**PLANNED UNIT DEVELOPMENT
& SUBDIVISION STAFF REPORT****Date: October 17, 2013****DEVELOPMENT NAME**

Teague Brothers Carpet Subdivision

Planned Unit Development Approval to allow multiple
buildings on a single building site, and Subdivision approval to create one legal lot of record.

SITE PLAN

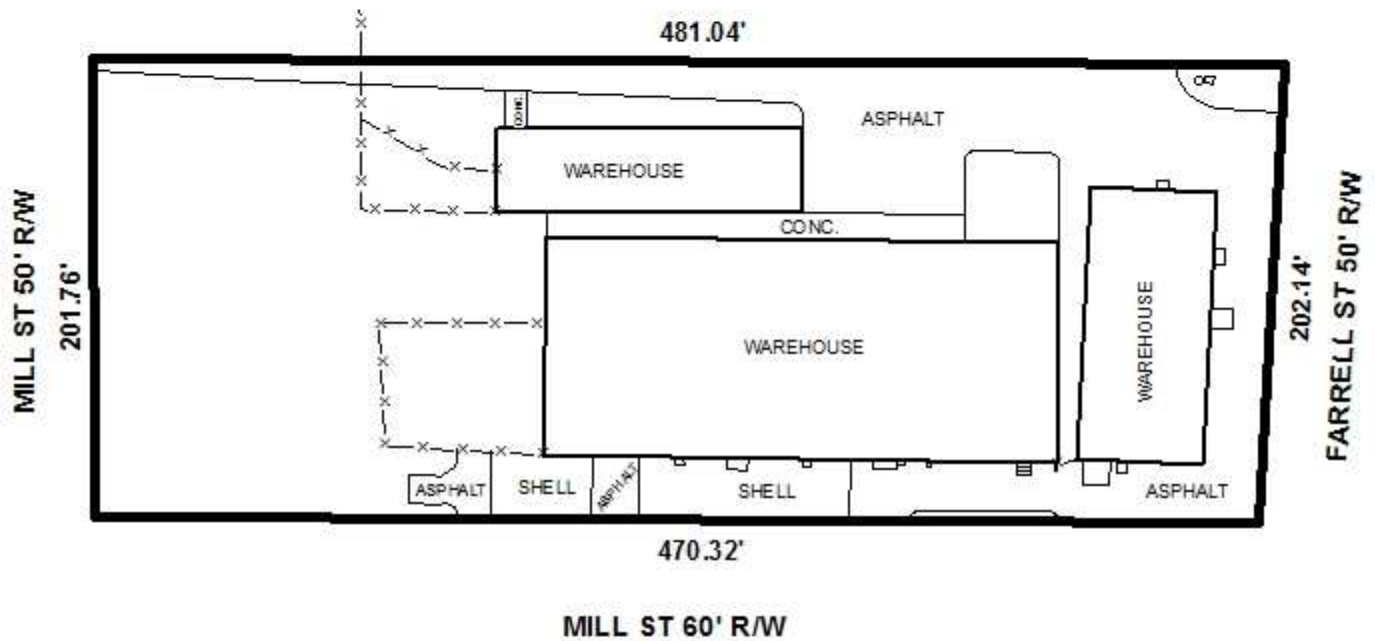
With regard to the PUD, the site plan indicates a non-compliant site in that there are numerous access points with substandard access/maneuvering areas between the buildings and rights-of-way, no parking calculations and no designated parking, no landscaping or tree planting, no dumpster, and no sidewalks. The applicant states that there is no additional construction proposed at this time and repairs will be made to existing buildings as needed and landscaping will be maintained that will improve the quality of the appearance of the site.

No public sidewalks are indicated along the street frontages. The site plan should be revised to indicate such, or a Sidewalk Waiver application submitted. As the applicant is not proposing any new construction, it is recommended that the provision of a sidewalk be required at such time as new construction or redevelopment is proposed.

- 1) revision of the site plan to label the lot with its size in square feet and acres, after any required dedication; or the provision of a table on the site plan providing the same information;

- 2) revision of the site plan to indicate any required dedications of the Subdivision;
- 3) placement of a note on the site plan stating that the driveway number, size, location, and design are to be approved by Traffic Engineering and conform to AASHTO standards;

- 4) revision of the site plan to illustrate a 25' minimum building setback line along all street frontages;
- 5) revision of the site plan to provide parking calculations;

- 6) revision of the site plan at the time of new construction or redevelopment to provide a compliant dumpster or dumpsters, or the placement of a note on the site plan stating that dumpsters will not be utilized and refuse collection will be either curb-side or via a private collection service;

- 7) revision of the site plan at the time of new construction or redevelopment to provide landscaping and tree planting calculations and to meet the landscaping and tree planting requirements, as much as practicable, to be coordinated with Urban Forestry;

- 8) revision of the site plan at the time of new construction or redevelopment to indicate public sidewalks along all street frontages, or the submission of a Sidewalk Waiver application;
